Charlotte-Mecklenburg Planning, Design, & Development

SUBJECT: Administrative Approval for Petition No. 2014-002 The Rainier Group, LLC

ILLUSTRATIVE
 PLAN & NOTES

RZ1.0

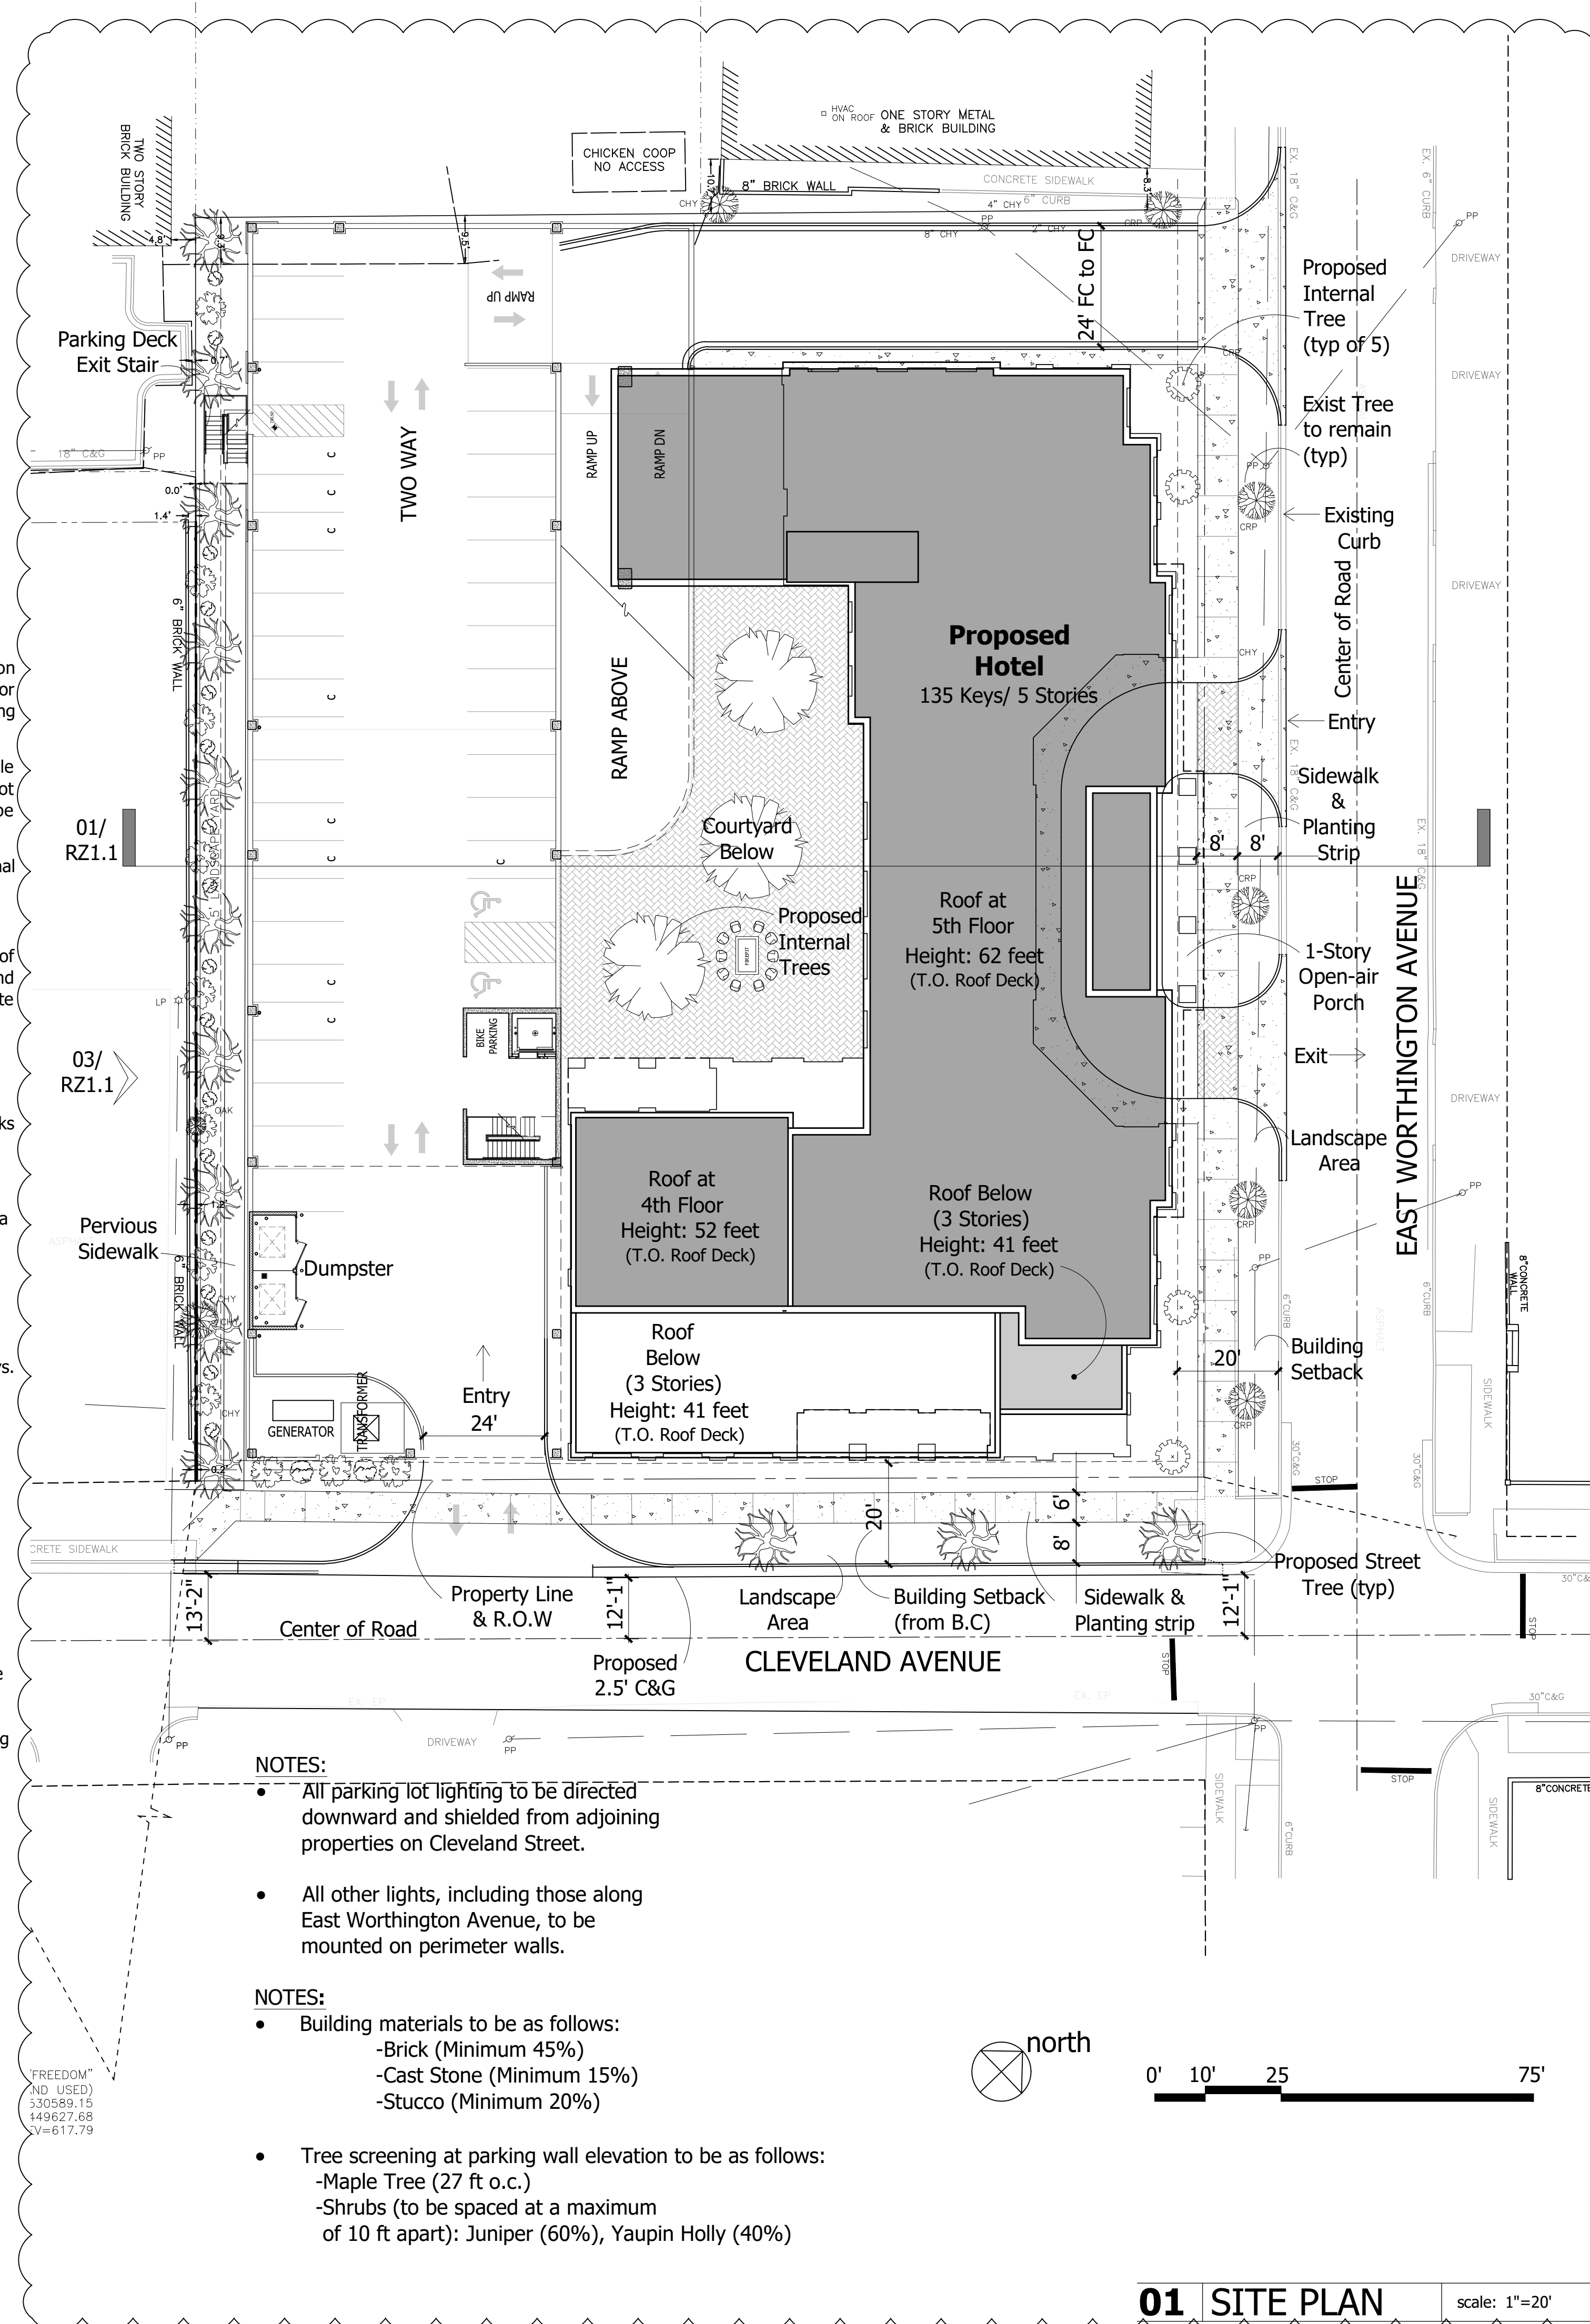
- Allows an increase of 5 five hotel rooms per section 6.207 for an overall total of 135 rooms.
- Modification to the proposed building elevations.

RZ1.1

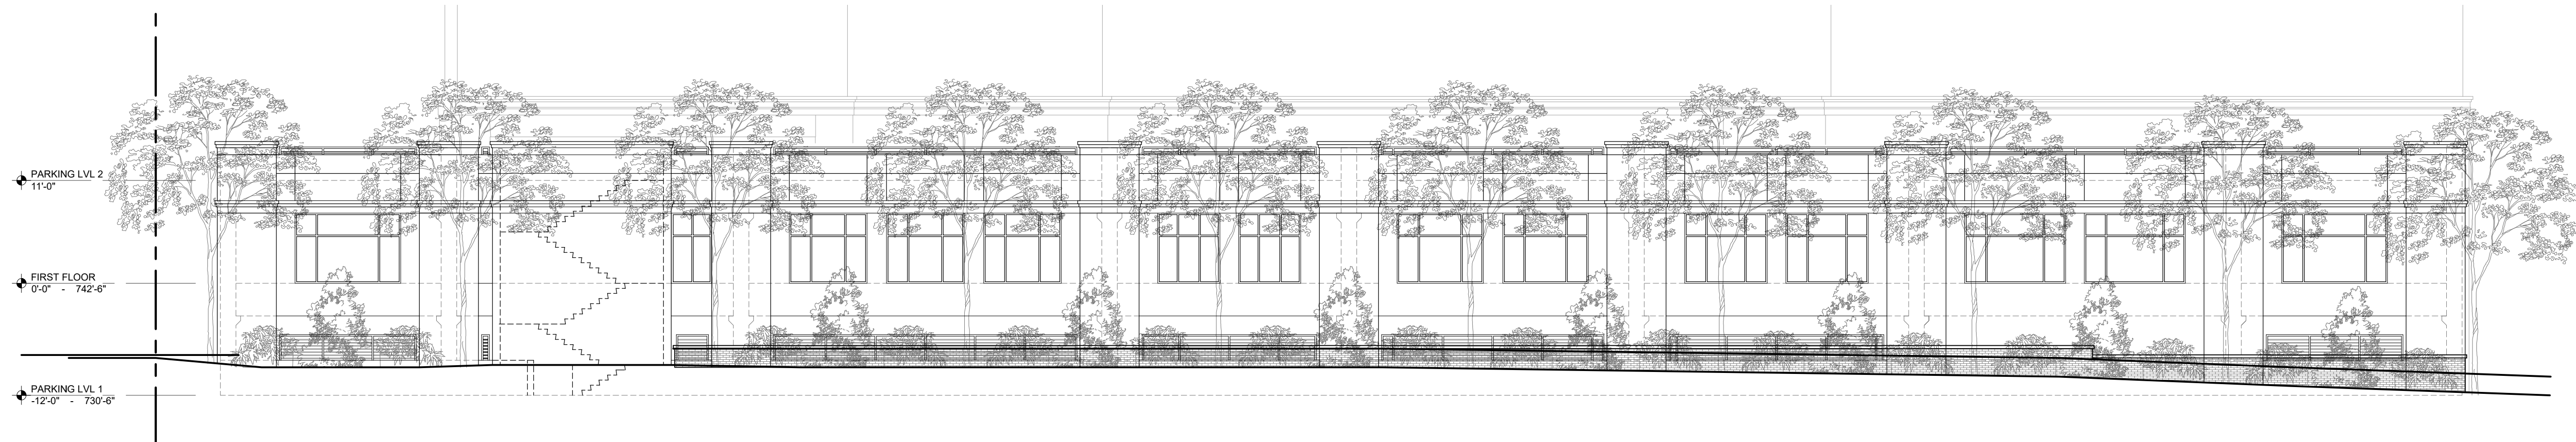
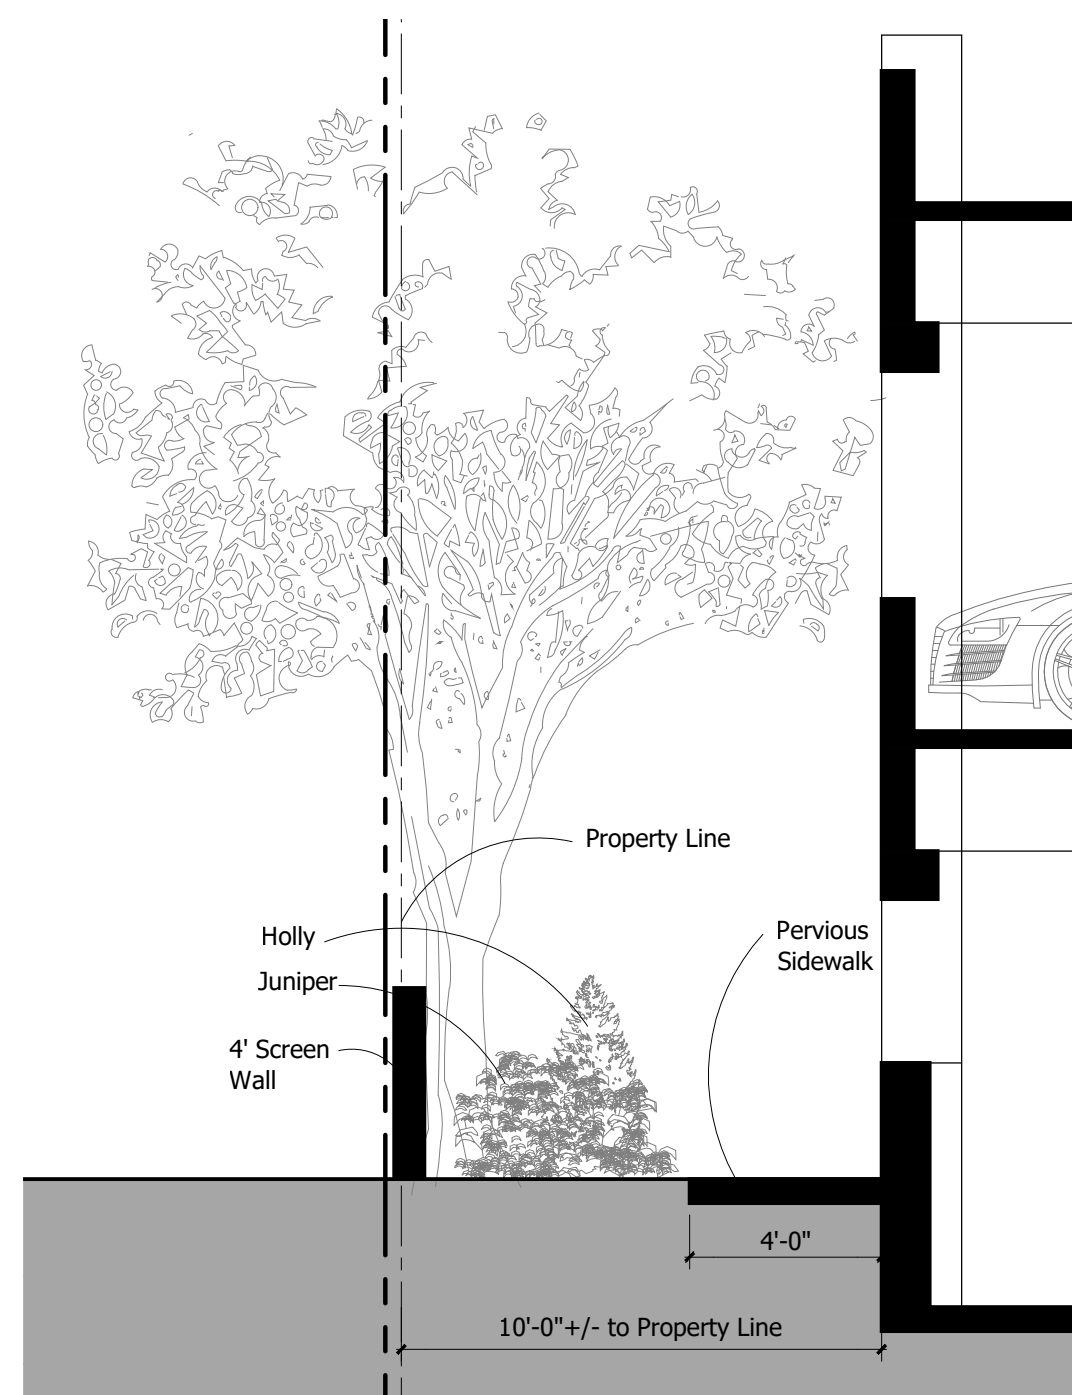
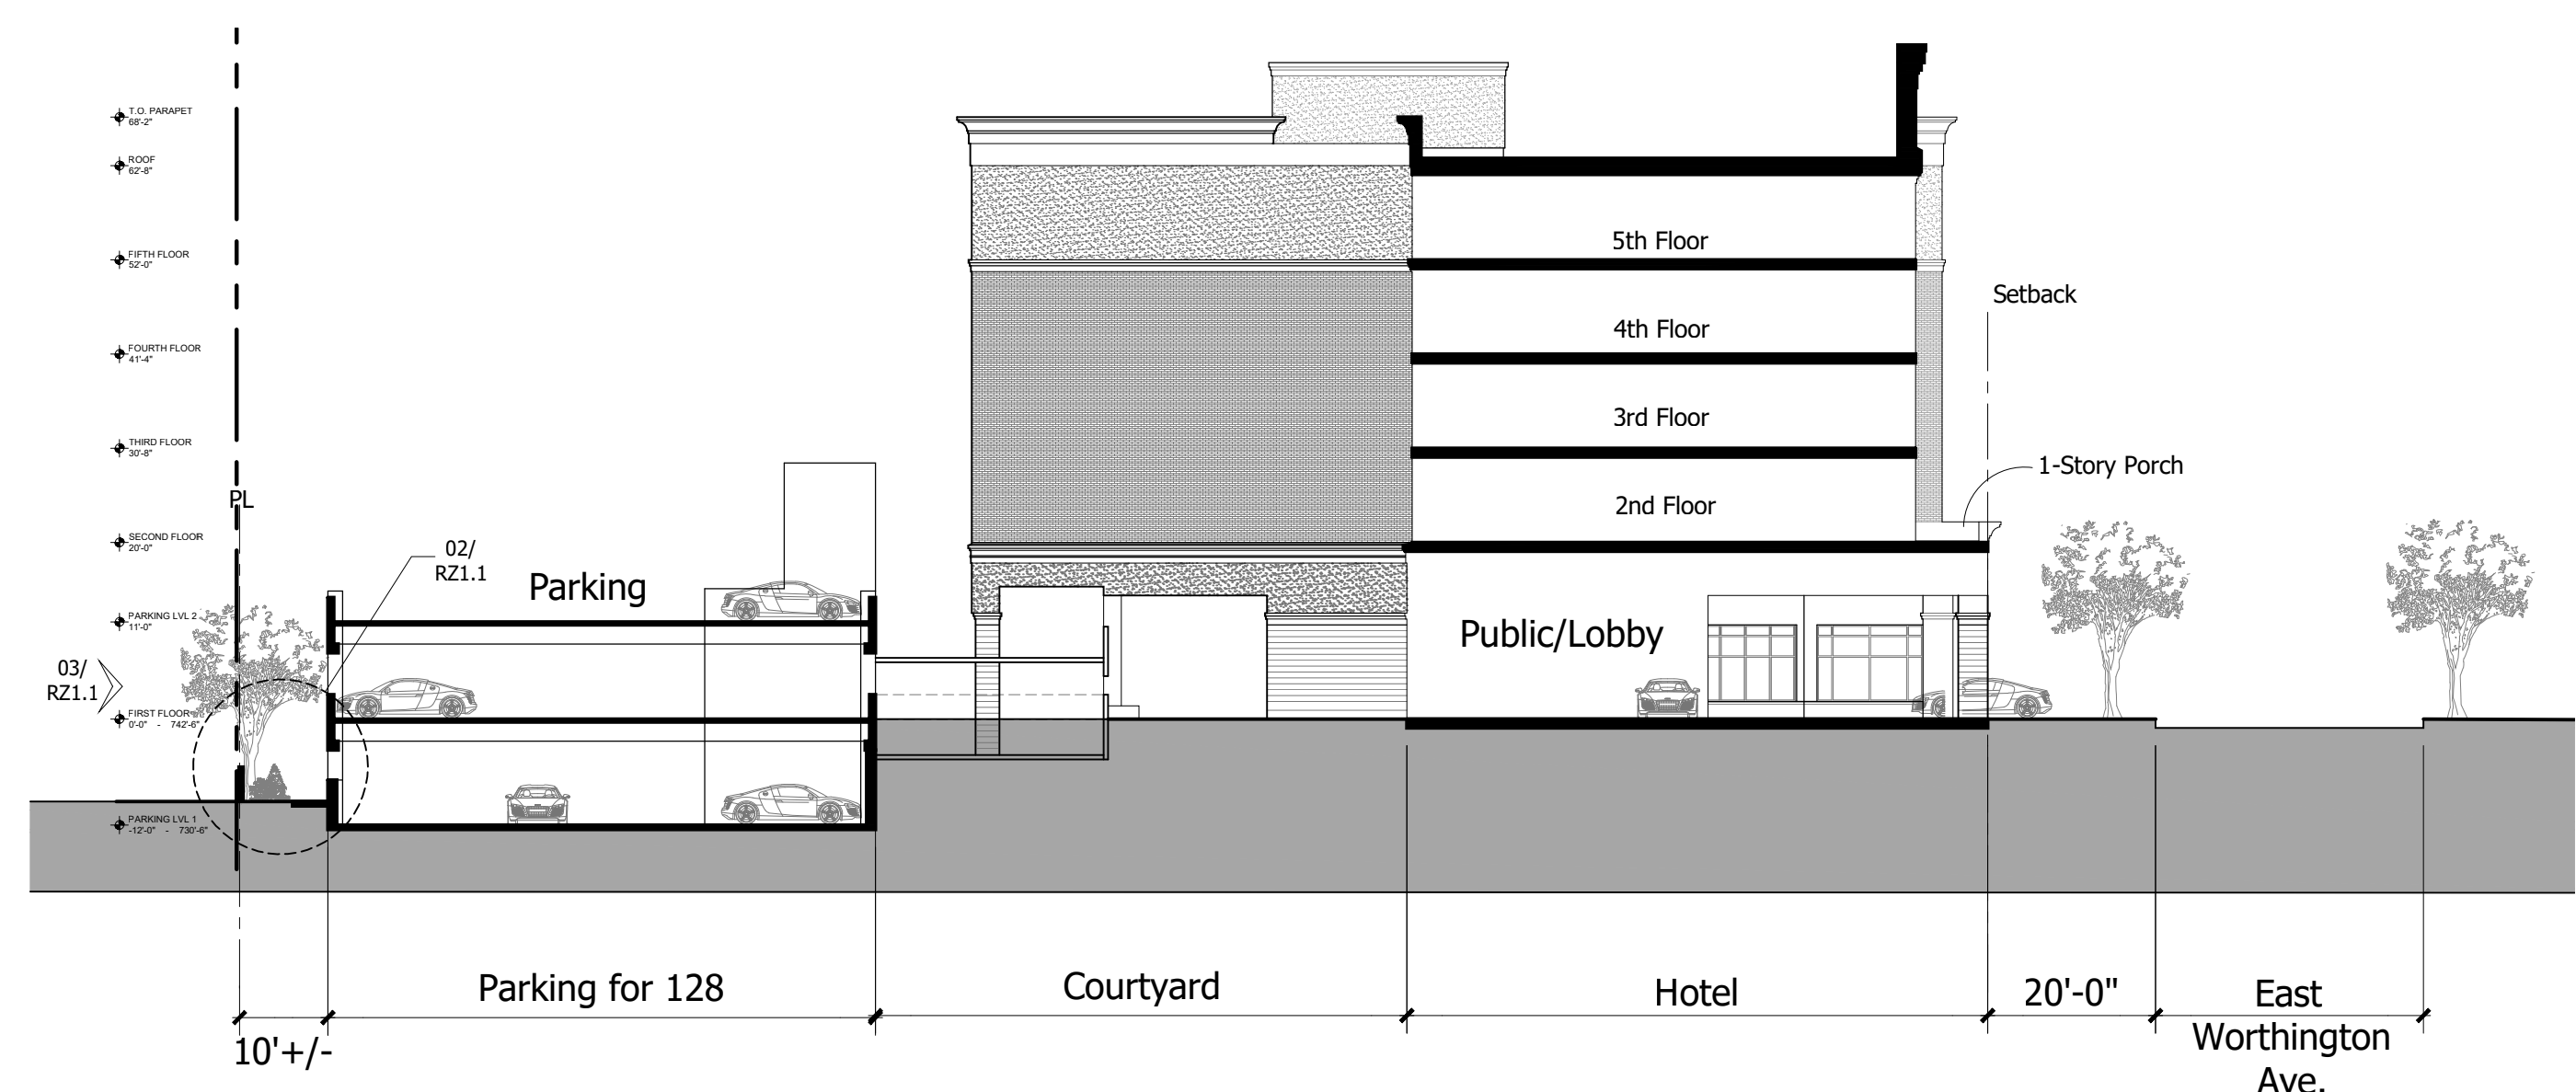
ENTIRE SHEET REVISED

- Building materials to be as follows:
 - Brick (Minimum 45%)
 - Cast Stone (Minimum 15%)
 - Stucco (Minimum 20%)
- Tree screening at parking wall elevation to be as follows:
 - Maple Tree (27 ft o.c.)
 - Shrubs (to be spaced at a maximum of 10 ft apart): Juniper (40%), Yaupin Holly (60%)
